**Submission in regards to DA2024/1376 Development Application ("the DA") at
7 Cooleena Road, Elanora Heights**

"Subdivision of one lot into two including demolition works, new driveway and carport."

Corona Projects has been engaged by the property owners of 30 Taitara Crescent, North Narrabeen to undertake an assessment of DA2024/1376 and provide a submission to Council on their behalf. 30 Taitara Crescent is located to the immediate south of the development site at 7 Cooleena Road (**"The Site"**). This assessment is based on a review of the development application plans and documents available for inspection on Northern Beaches Council's website and a site inspection.

Figure 4: Proposed connection to existing easement. Extract from stormwater plan (LODESSA, 2024)

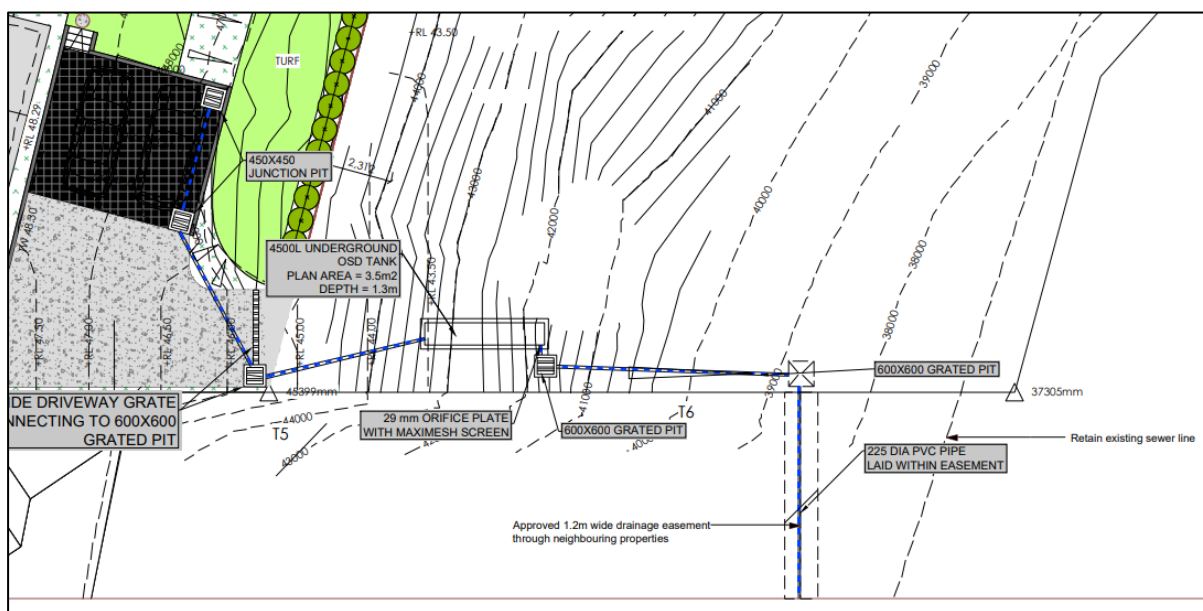
The concern is that any stormwater drainage system proposed on the subject site will not be adequate to manage the capacity of stormwater entering and leaving the site. The property owners note that the easement relied upon is defective and in need of repair. Details of the diameter and condition of the existing easement pipe have not been submitted with this application. Stormwater overflow poses significant risks to downstream properties, including damage to life and property, before reaching its final discharge point.

The proposed stormwater management documentation lacks clarity and requires thorough assessment combined with field work. A peg out survey and surveillance report need to be prepared by a suitably qualified plumber or engineer to examine the status of stormwater easement, to understand the discharge point of this easement, and to prepare a list of upgrade works. These documents shall be provided to Council and the neighbours for further comment.

Discrepancy is also identified in the proposed stormwater arrangement. Item 9.5.2 of submitted geotechnical report prepared by AW Geotechnical Pty Ltd (dated 11 Oct 2017, Rev B) recommends to *“discharge stormwater via a spreader, and not a concentrated discharge, in order to not adversely affect to the geotechnical stability of the steep slope at the rear, or any public/ private assets downslope”*. However, we note the proposal drains stormwater through an easement with proposed underground OSD and raingarden for quality increase. It is unsure how the proposed stormwater arrangement aligns with the recommendation in geotechnical report; therefore, we respectfully ask Council’s Engineering Team to conduct a comprehensive review to ensure stormwater can be adequately managed and discharged to a suitable location.

Figure 6: Proposed tree removal plan overlaid on plan showing future dwelling footprint.

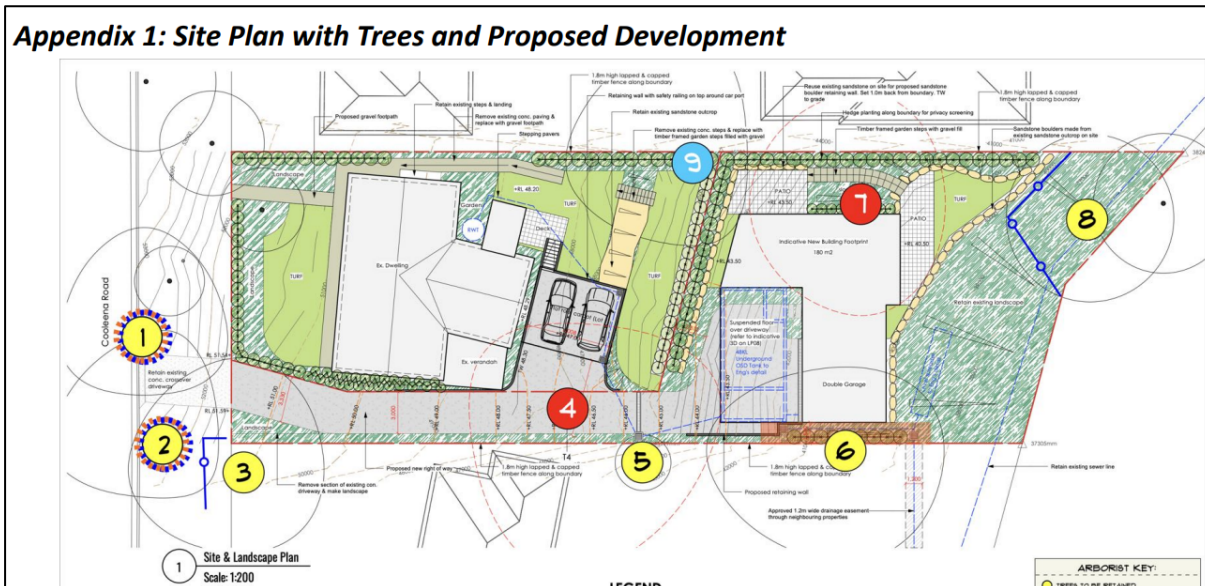
With reference to the submitted Arborist Report prepared by Advanced Treescape Consulting (dated 21 Aug 2024), Tree 4 (pepper tree) and 7 (red cedar) are proposed for removal. The proposed tree removal is not supported as it will create irreversible adverse impact to the local ecosystem and will disturb the established vegetation corridor located along the rear of residential properties nearby.

It is further noted that additional trees may be impacted by the development. Tree 1 (street tree) is located within close proximity of the proposed driveway. Tree 5 and 6 (located on neighbouring property) will likely be impacted by the construction due to their proximity to driveway and future dwelling footprint. The submitted arborist report did not give regard in the possible removal of these trees. No detail in regards to replacement planting (tree species, pot size, planting specification etc) is provided.

Figure 10: Geotechnical Hazard Map - Pittwater LEP 2024

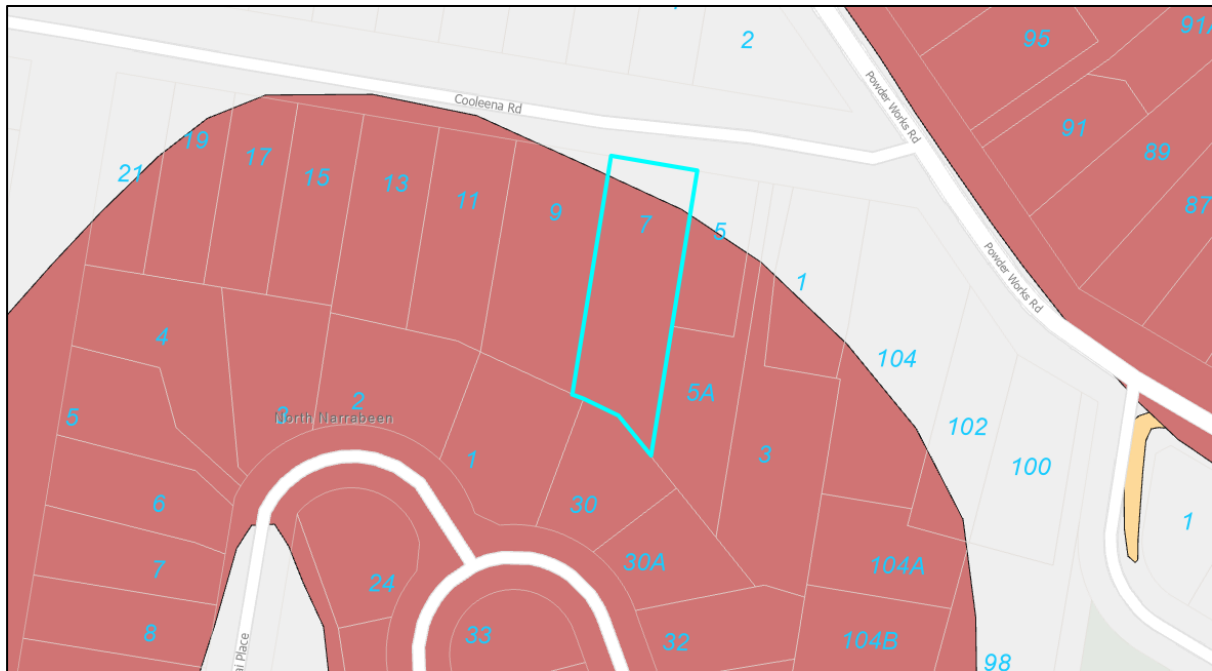
The Pittwater LEP identifies most of the site as land with geotechnical hazard “H1”, which indicates the possibility of landslip event as “possible, likely, to almost certain”. Review of the site survey shows the fall of land varies between 9 to 30 degrees.

We therefore request Council to conduct a comprehensive review of the geotechnical report and assess the proposal against Clause 7.7 of PLEP, and impose conditions where applicable to ensure no unwarranted ground movement will be triggered by the proposal.

Figure 12: Nominated RL on architectural plans.

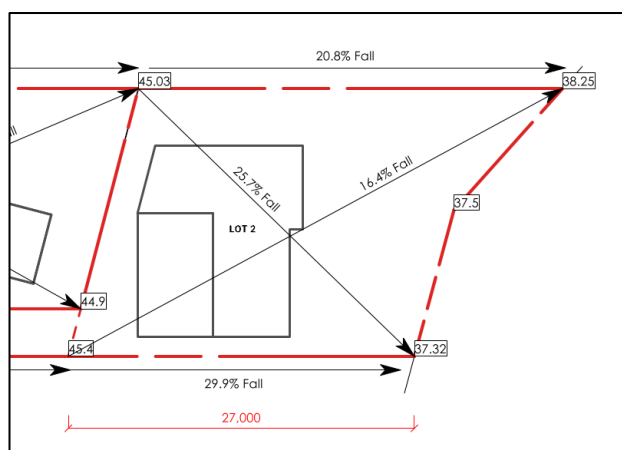
We also contend there are insufficient information to demonstrate compliance with the topography requirement under B2.2. The submitted architectural plan nominates the level of the south western and south eastern corner as RL37.32 and RL38.25 respectively. However, the submitted survey does not appear to have surveyed the existing ground level of area towards the south of rock outcrop, mostly due to the difficulty in gaining access. As a result of the steep nature of the site, the actual RL of these corners are likely to be lower than the nominated level. Therefore, the western boundary of Lot 2 is highly unlikely to meet the slope requirement and Lot 2 will not be considered suitable to be a separate allotment.
